Technical Service Information

ZF 4HP-18 FLE/FLA NEUTRAL AFTER A3-4 UPSHIFT

Figure 1

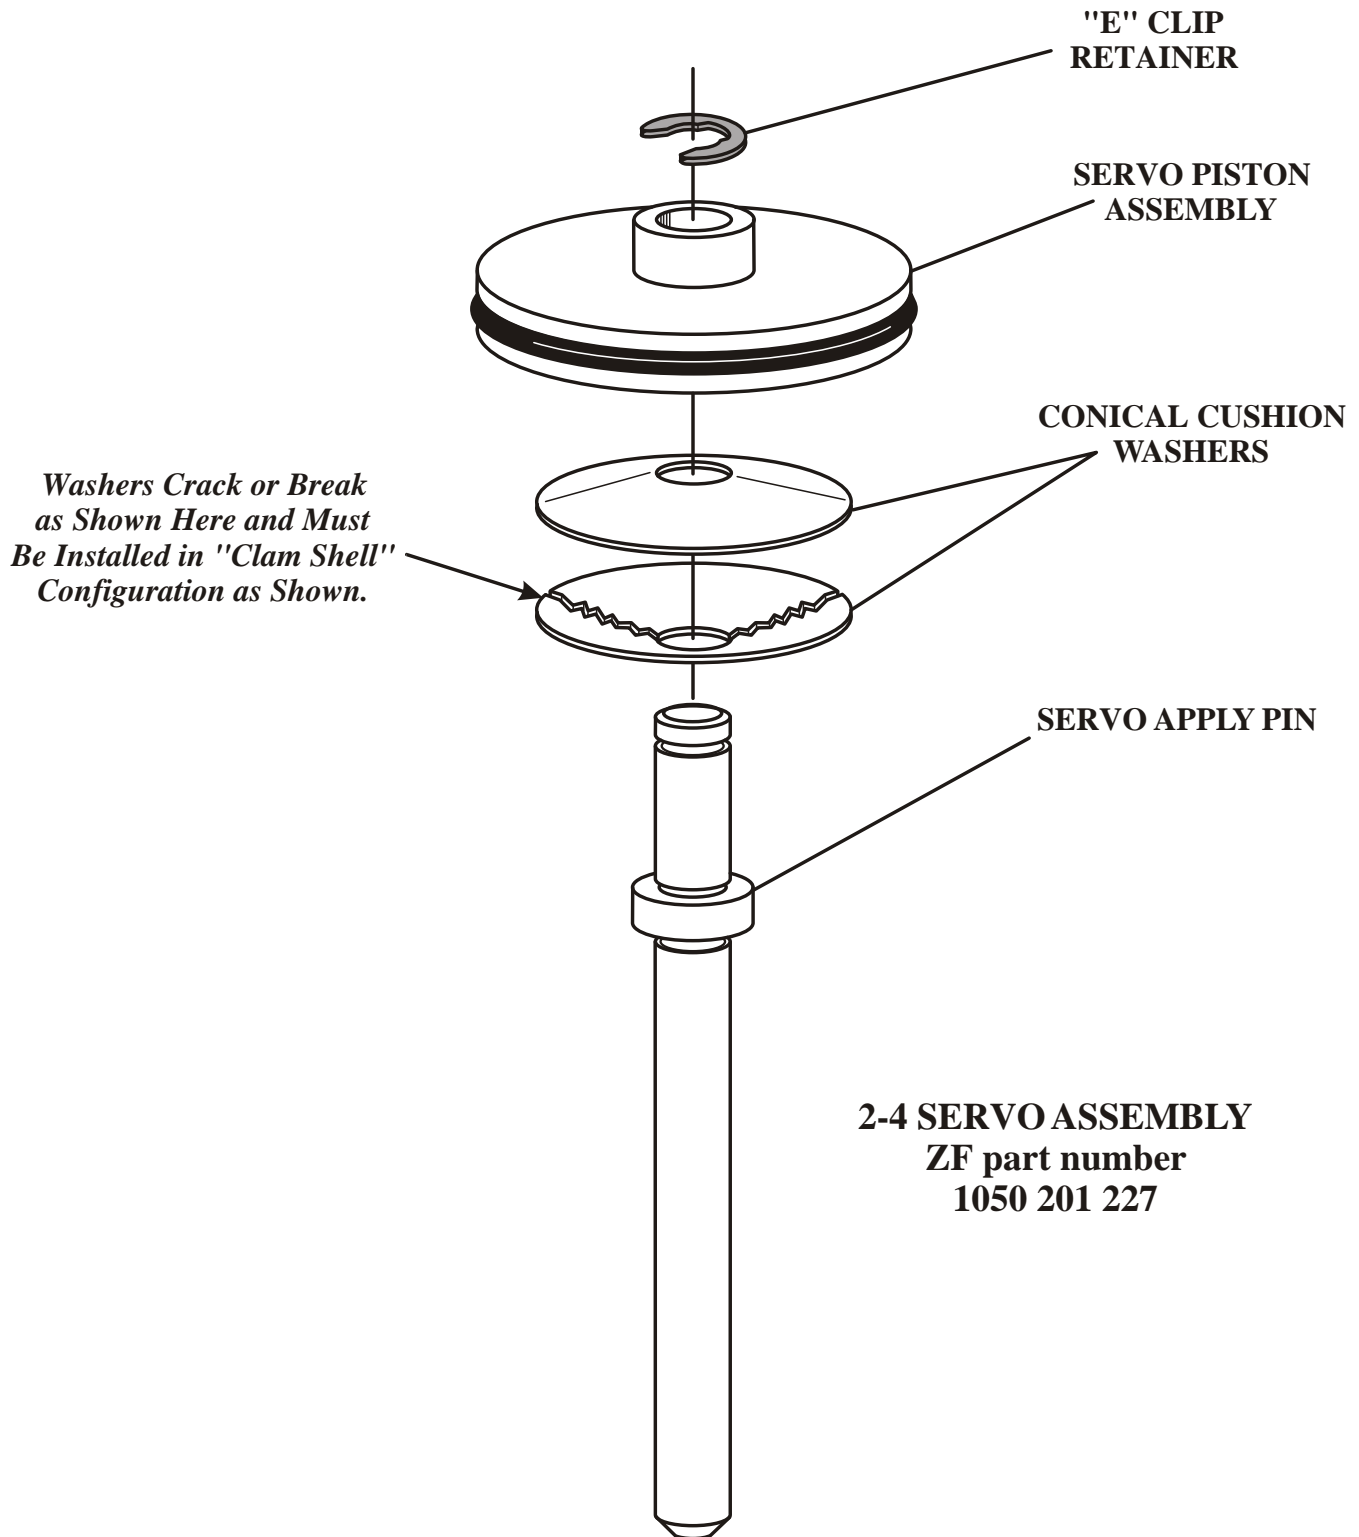
COMPLAINT: Vehicles equipped with the ZF 4HP-18 FLE or FLA may exhibit a neutralizing condition on the 3-4 upshift, then a neutral condition when the vehicle comes to a stop. After an ignition cycle the vehicle will then move forward, but will go through the whole cycle once the 3-4 shift is attempted again.

CAUSE: The cause may be split conical cushion washers in the 2-4 servo assembly as shown in Figure 1. This will create a neutral condition when the band is re-applied in 4th gear, because of the broken cushion washers limiting the travel of the servo. **NOTE: The 2-4 servo is also applied in 2nd gear but only provides engine braking because of the application of the "C" clutch in 2nd gear. See Figure 2 for the Clutch and Band application chart.** The Transmission Control Module will put the transmission in a "Fail Safe Mode" when it neutrals out in 4th. In this situation, this is a 4th gear command (all solenoids OFF), which is now Neutral. The driver of the vehicle will have to cycle the ignition switch to regain forward application.

CORRECTION: Replace the conical washers, as shown in Figure 1. The entire 2-4 servo assembly can be purchased through an authorized ZF parts distributor, as the conical washers are not sold separately. If good used conical washers are found, ensure that the washers are assembled in a "clam shell" configuration, as shown in Figure 1.
